Nanga Road, Waroona WA

Road Improvements between Slk 0.37 – 2.02.

Road Safety Audit

Stage 3 - Detailed Design

Finding 2.2 – – Insufficient sight distance from the side-track. Consider closing the access to the road.

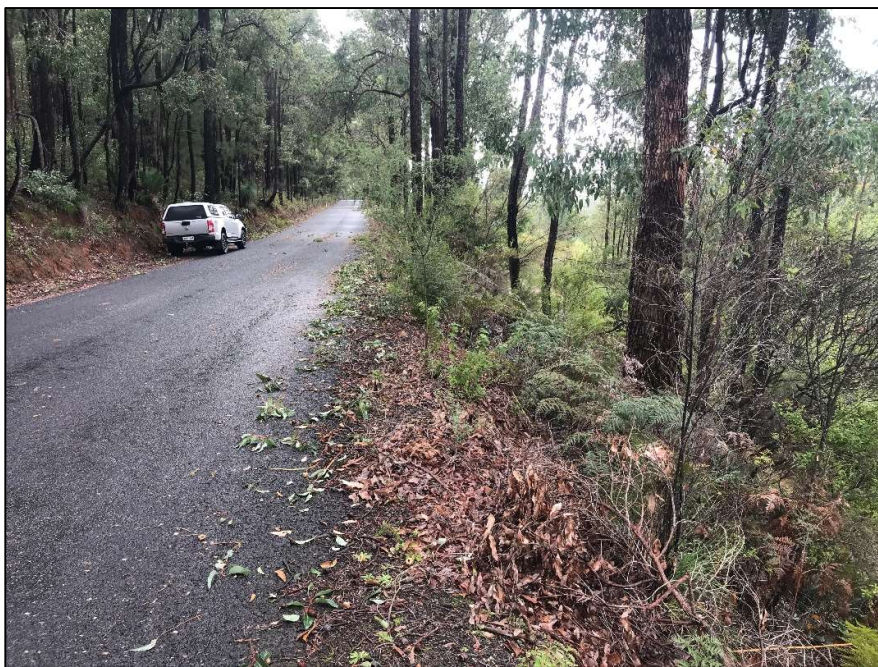
Clear the vegetation to provide Safe Intersection Sight Distance at the intersection locations.

Remove access from tracks where access is unsuitable.
